APPLICATION NO.	FILING DATE	FIRST NAMED INVENTOR	ATTORNEY DOCKET NO.	CONFIRMATION NO
10/001,708	10/18/2001	John B. Stoick	2267.629US01	2958
24113 75	590 04/20/2005		EXAMINER	
PATTERSON	I, THUENTE, SKAAR &	ALIE, GHASSEM		
4800 IDS CEN' 80 SOUTH 8TH			ART UNIT	PAPER NUMBER
	MINNEAPOLIS, MN 55402-2100			
			DATE MAILED: 04/20/2000	•

1 4 1: 1: 1: 1:	
	Application No.	Applicant(s)
Office Action Comments	10/001,708	STOICK ET AL.
Office Action Summary	Examiner	Art Unit
	Ghassem Alie	3724
The MAILING DATE of this communication app Period for Reply	ears on the cover sheet with the c	orrespondence address
A SHORTENED STATUTORY PERIOD FOR REPLY THE MAILING DATE OF THIS COMMUNICATION. - Extensions of time may be available under the provisions of 37 CFR 1.13 after SIX (6) MONTHS from the mailing date of this communication. - If the period for reply specified above is less than thirty (30) days, a reply if NO period for reply is specified above, the maximum statutory period w - Failure to reply within the set or extended period for reply will, by statute, Any reply received by the Office later than three months after the mailing earned patent term adjustment. See 37 CFR 1.704(b).	36(a). In no e

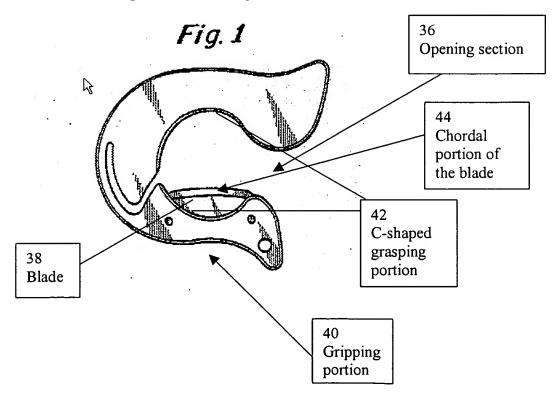
Regarding claims 12 and 13, Hockfeld teaches everything noted above including that grasping portion 42 makes substantial surface contact around the circumference of the tubing a distance necessary to forcefully receive the tubing. A tubing with slightly larger diameter than the grasping portion inherently could be snapped into the spaced within the grasping portion. Hockfeld also teaches that the contact around the circumference of the tubing is a distance between 51 to 75 percent of the circumference of the tubing. See Fig. 1 below.

6. Claim 1-4, 6-10, and 15-20, as best understood, are rejected under 35 U.S.C. 103(a) as being unpatentable over Hochfeld in view of Baltuch (2,254,199), or Mancini (Des. 362,168). Regarding claim 1, Hochfeld teaches a cutter that is capable of snapping onto and circumferentially grasp plastic tubing to facilitate the rotational cutting of the tubing. Hochfeld also teaches a cutter body and a C-shaped grasping portion 42 formed in the body and grasping portion 42 includes an opening 36 and a tube receiving portion. Hochfeld also teaches that opening 36 has a width generally less than the width of the tube receiving region such that C-shaped grasping portion 42 receives the plastic tubing with snap engagement retains the plastic tubing during the cutting of the tubing. The opening section of the grasping portion has a width less than the tube receiving region of the grasping portion such that plastic tubing needs to be forced onto the opening section in order to be placed within the tube receiving region of the grasping portion. Hochfeld also teaches a non-movable blade 38 secured to the body such that a chordal portion 44 of the blade extends into the grasping portion whereby rotational movement of the engaged cutter around the outer surface of the tubing facilitate cutting. It should be noted that grasping portion 42 has a circular-shaped receiving portion and non-movable blade 38 extents into the grasping portion. A chordal portion 44 of the blade extends into the circular-shaped receiving region of grasping portion 42 in the same manner that a chordal portion of the blade extents into the grasping portion in the instant invention. See Fig. 1 in Hochfeld and the instant invention. See Fig. 1 below.

Regarding claims 2-4 and 6, Hockfeld teaches everything noted above including that the inner diameter of C-shaped grasping portion 42 is smaller than the outer diameter of the tubing. A tubing with slightly larger diameter than the grasping portion inherently could be snapped into the spaced within the grasping portion. The rotational movement of the cutter inherently cuts the tubing a distance short of the thickness of the tubing. Hockfeld also teaches that the blade 38 is a single-edged razor blade. See Fig. 1 above.

Regarding claim 15, Hockfeld as modified above teaches everything noted above including a gripping portion 40 formed in the body by at least one arcuate depression for human handing of the cutter. See Fig. 1 above in Hockfeld.
